**Louisville Southern Indiana Ohio River Bridges Project
Kentucky Historic Preservation Advisory Team
Meeting – October 25, 2005
SUMMARY**

Section 1 (Kennedy Interchange): Glen Kelly, Richard Sutherland, Dan Byers and David Smith, KTA

Design Section 1

KENNEDY INTERCHANGE

Single Point Urban Interchange (SPUI) at Mellwood

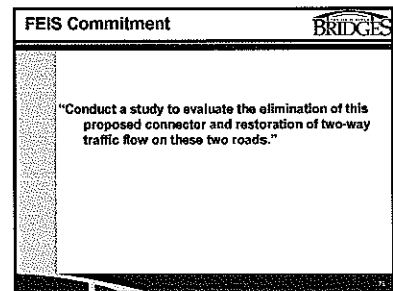
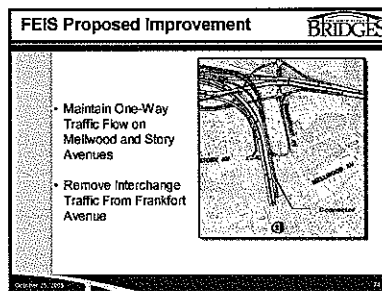
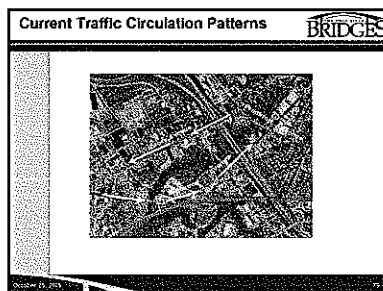
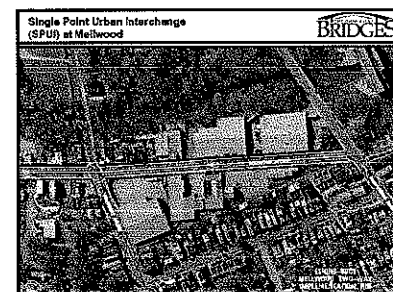
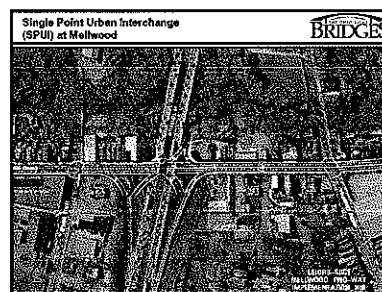
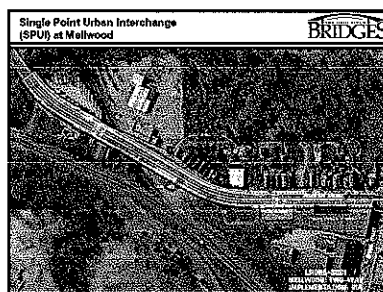
- Bart Bryant asked the team if the Mellwood/Story Interchange should be further studied. Butchertown expressed that the study should be continued further and made the motion to proceed with the 2-way study of Mellwood/Story with a single point interchange. Metro Government seconded the motion. The motion was voted on by the KHPAT and defeated; the members would appreciate some additional time to review.

- Ms. Barras asked for an identification of potential business impacts for that portion of Mellwood between Frankfort Avenue and Brownsboro Road. Mr. Sutherland responded that it would be significant.

- Ms. Barras stated River Fields would like to have additional time to review the Mellwood/Story information that was presented. She would also like to know the cost effectiveness of the design alternative.
